HISTORIC AND DESIGN REVIEW COMMISSION

May 04, 2022

HDRC CASE NO: 2022-228
ADDRESS: 114 SWEET
LEGAL DESCRIPTION: NCB 2563 BLK C LOT 4 & W 20 FT OF 5
ZONING: RM-4, H
CITY COUNCIL DIST.: 1
DISTRICT: Nathan Historic District
APPLICANT: Nathan Manfred/French & Michigan
OWNER: Stephanie Chapman
TYPE OF WORK: Construction of a rear addition and carport, fencing
APPLICATION RECEIVED: April 14, 2022
60-DAY REVIEW: Not applicable due to City Council Emergency Orders
CASE MANAGER: Edward Hall

1 114 SWEET - REMODEL & ADDITION PLAN
SCALE: 1/4" = 1'-0"

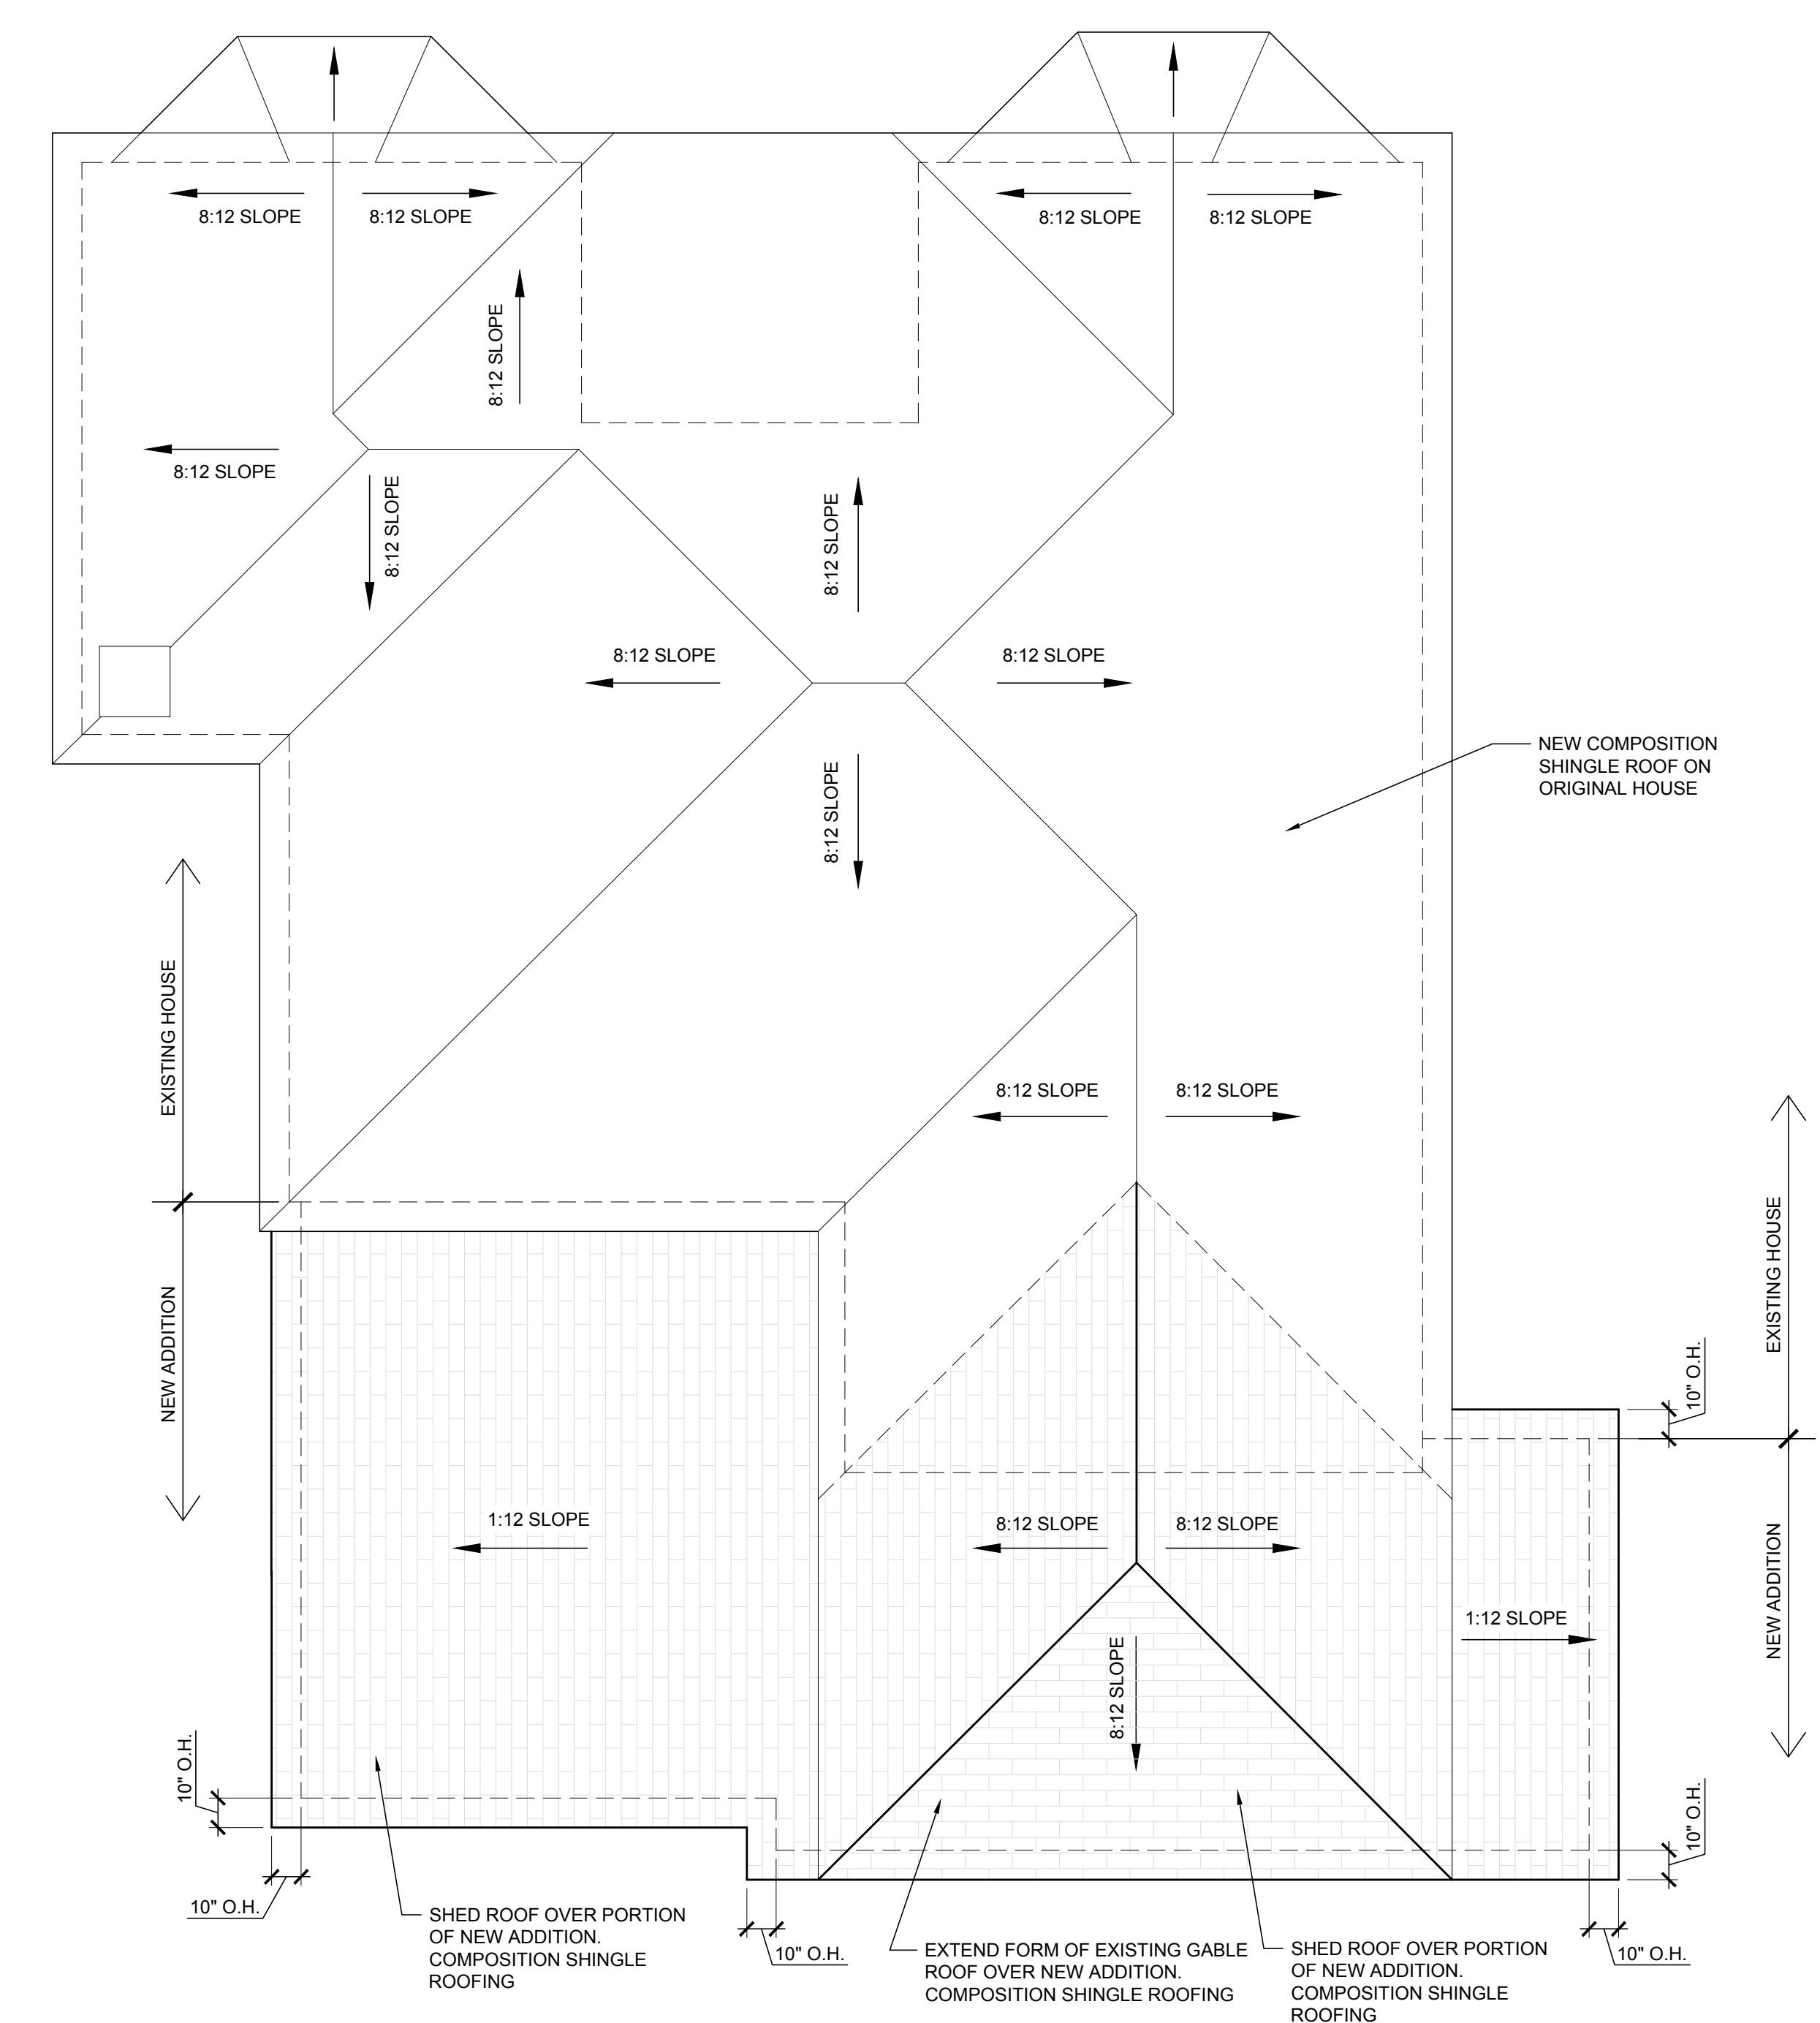
- c. **REAR ADDOTOPM** – The applicant has proposed to construct a rear addition to feature 500 square feet.
- d. **REAR ADDITION** – The Guidelines for Additions 1.A. notes that additions should be sited to minimize view from the public right of way, should be designed to be in keeping with the existing, historic context of the block, should feature similar roof forms, and should feature a transition to differentiate the new addition from the historic structure. Additionally, the Guidelines for Additions 1.B notes that additions should be subordinate to the principal façade of the historic structure, should feature a footprint that responds to the size of the lot, should not double the existing building footprint, and should feature an overall height that is generally consistent with that of the historic structure. Staff finds the proposed addition to be appropriate and consistent with the Guidelines.

- g. ARCHITECTURAL DETAILS – Generally, staff finds the proposed addition's architectural details to be appropriate and in keeping the Guidelines for Additions. Staff finds that the proposed rectangular, fixed windows should feature traditional sizes and should be in a sash configuration.

- ii. That the proposed rectangular, fixed windows be replaced by windows that feature traditional sizes in a sash configuration.
2. Staff recommends approval of item #2, the construction of a carport, based on finding h with the following stipulation:

2 114 SWEET - PROPOSED SITE PLAN
SCALE: 3/16" = 1'-0"

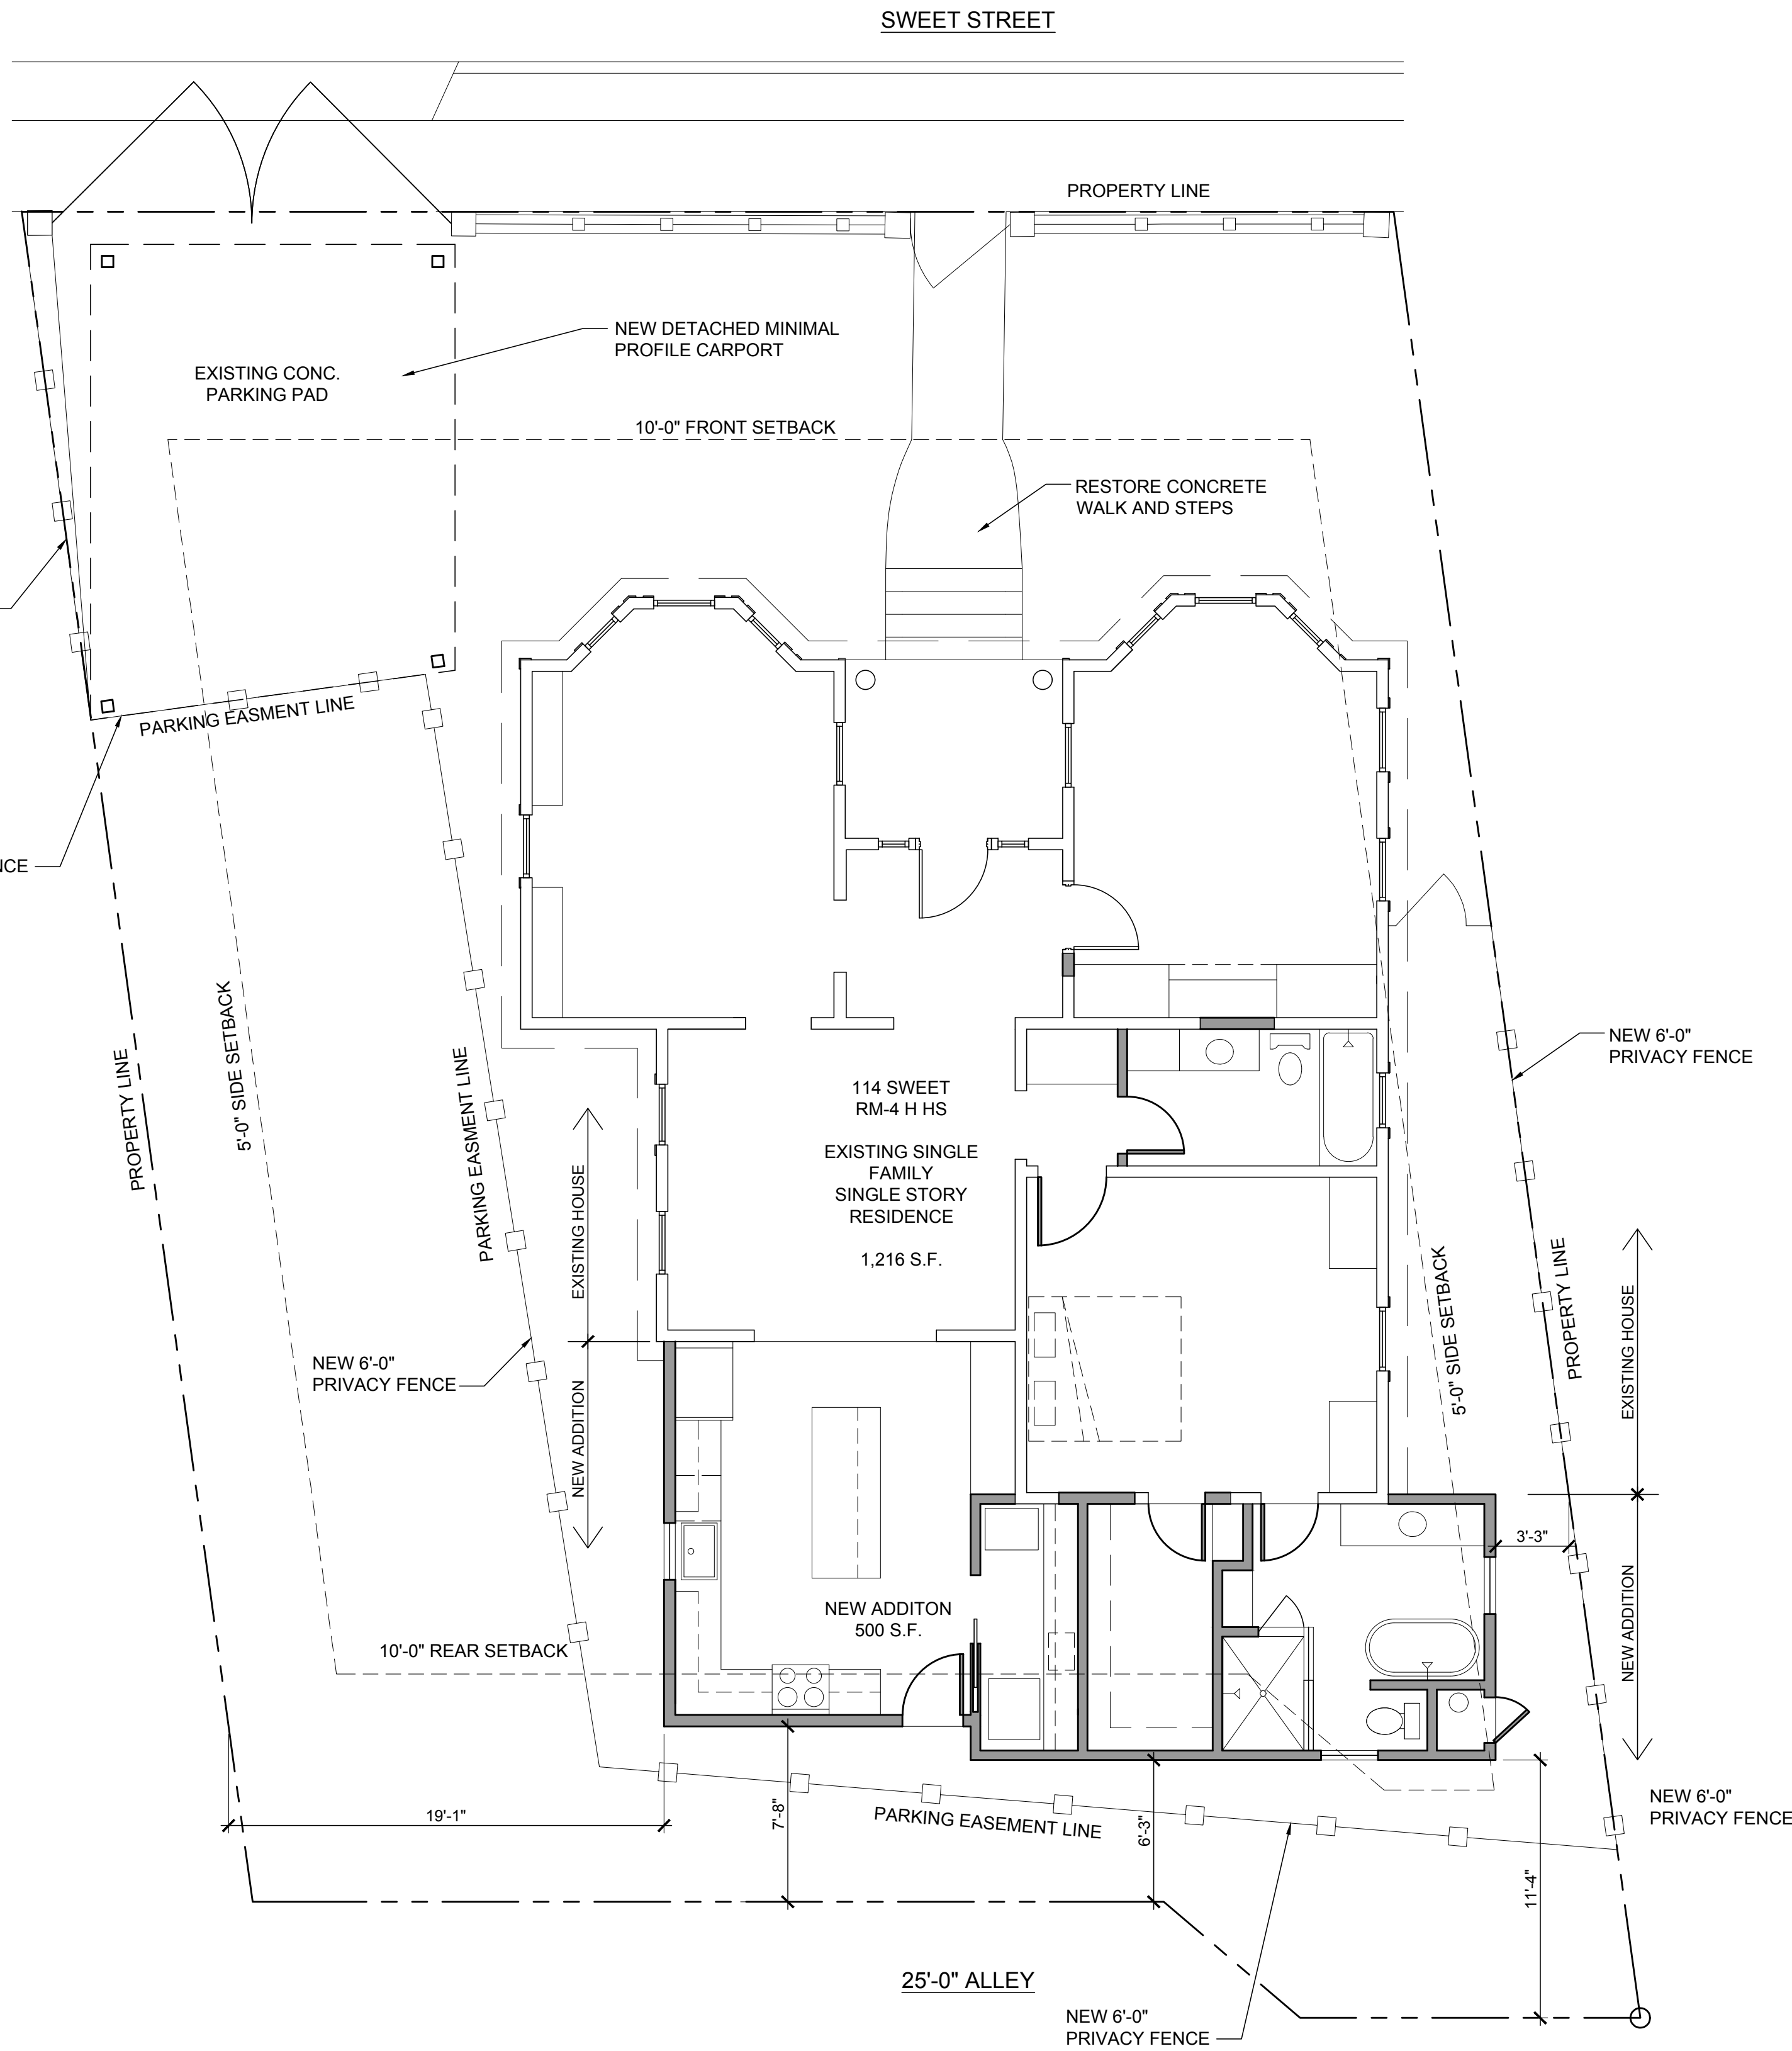
- h. CARPORT – The applicant has proposed to construct a detached carport to feature metal construction to be located adjacent to the right of way. The Guidelines for New Construction 5. note that garages and outbuildings should be located in a manner that is consistent with the traditional setback found on the block. The proposed location adjacent to the right of way is not consistent with the Guidelines; however, due to existing site conditions, staff finds the proposed location to be appropriate. Additionally, the Guidelines note that rear accessory structures should relate to the primary structure on the lot regarding materials and simplified architectural details. Staff finds that the applicant should incorporate materials that are consistent with those found on the historic structure into the design of the garage.

- i. PRIVACY FENCING – The applicant has proposed to install privacy fencing to start at the rear of the proposed carport and extend to the rear of the property. Staff finds that the proposed privacy fencing should begin behind the front-most side window on the west façade, as the Guidelines say that privacy fencing should be set behind the front façade rather than align with it.

- i. That the applicant provide enough depth to ensure that vehicles do not park in a manner that impedes the sidewalk.
 - ii. That the applicant incorporate materials (wood) that are complementary of the historic structure into the design of the carport.

3. Staff recommends approval of item #3, the installation of privacy fencing with the stipulation that the proposed privacy fencing start behind the front-most side window on the west façade.
